TECHNICAL SERVICE BULLETIN

Bulletin Number: V-15-03
Model Years: 2015

SUBJECT: 2015 Victory Motorcycles – Idle Air Control Replacement / ECM Reflash

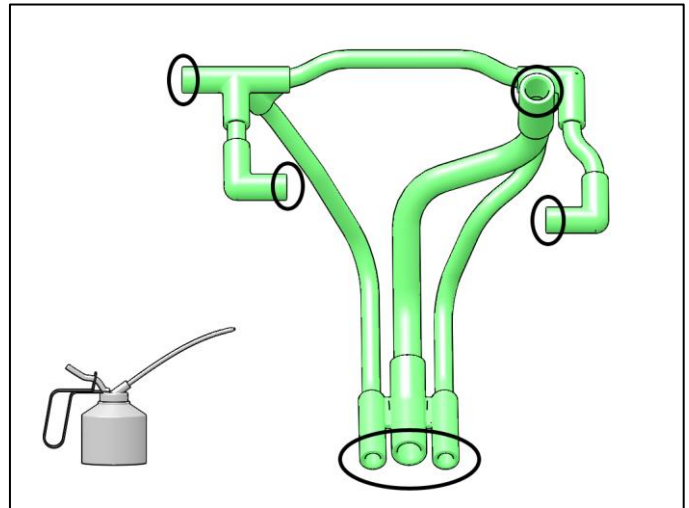
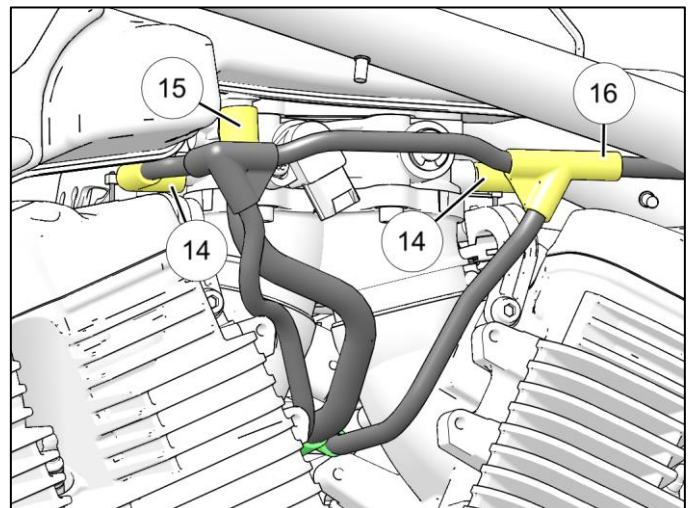
12. Disconnect the Charcoal Canister purge line ⑩ from the Idle Air Control T-Fitting.
13. Disconnect the supply fitting ⑪ from the air box, the forward IAC fitting ⑫ and the rear IAC fitting ⑬ from the throttle body.
14. Unplug the Cylinder Head Temperature sensor (CHT) connector to provide additional clearance when fitting the new IAC hose assembly.

16. Feed the IAC hose assembly through the engine from the primary cover side and connect the front and rear throttle body fittings ⑭, the air box fitting ⑮ and the charcoal canister fitting ⑯.
17. Reconnect the CHT sensor and verify that the wire harness is not pressing on the IAC hose assembly causing it to flex.

15. Apply P80 (or similar) lubricant to hose connections on the new IAC hose bundle.
